INTEROFFICE MEMORANDUM

Reference #: PD-21-12-029

TO : Sales Mgt. / Sales Admin / PAU / DICD
CC : D&E / Customer Care / Marketing / Construction / BPU / PD File
FROM : Project Development
DATE : December 21, 2021
SUBJECT : The Celandine (CEL)
Basement Level Updated Availability Plans

Please be informed of the updated basement level 1, 2 and 3 availability plans for **THE CELANDINE (CEL)** with reference # DE-21-11-012 dated November 11, 2021. Kindly ensure that old files will be properly replaced and updated by the new plans.

THE CELANDINE
BASEMENT LEVEL 1 FLOOR PLAN
APRIL 2021
PER MEMO REF. DE-21-04-018

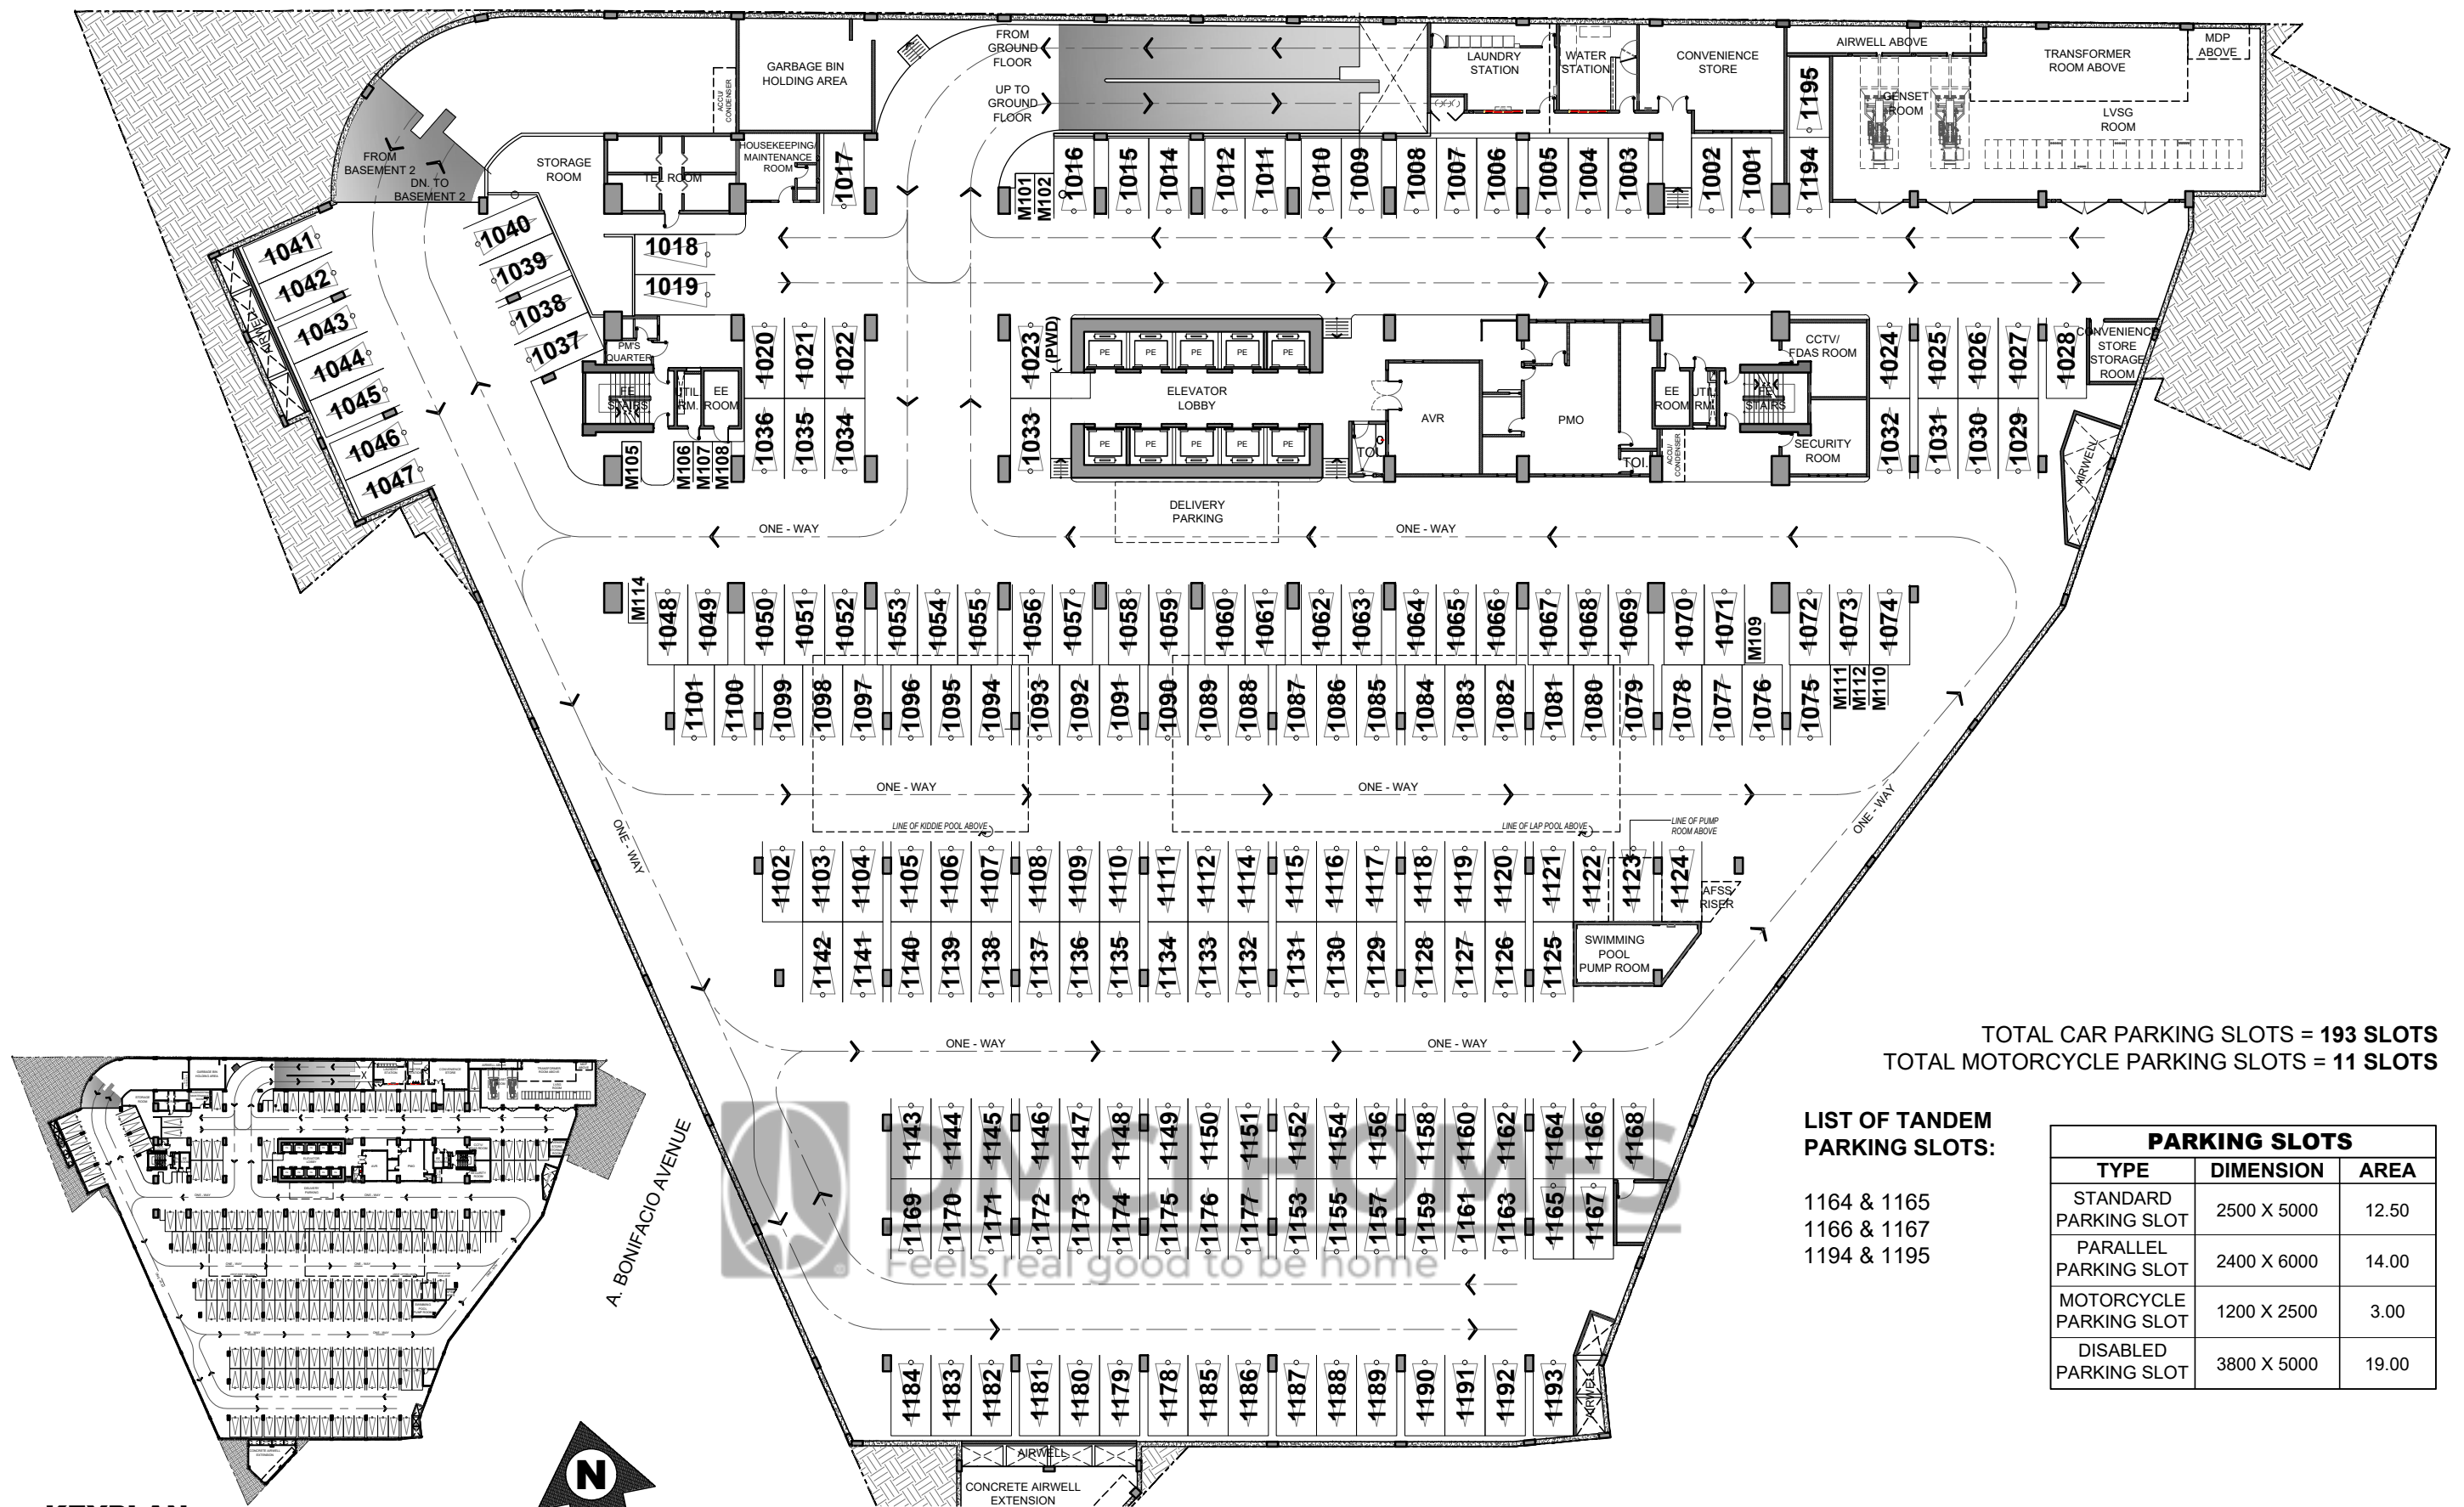
- i. Relocation of Motorcycle Parking Slots M110, M114, M236 and M336
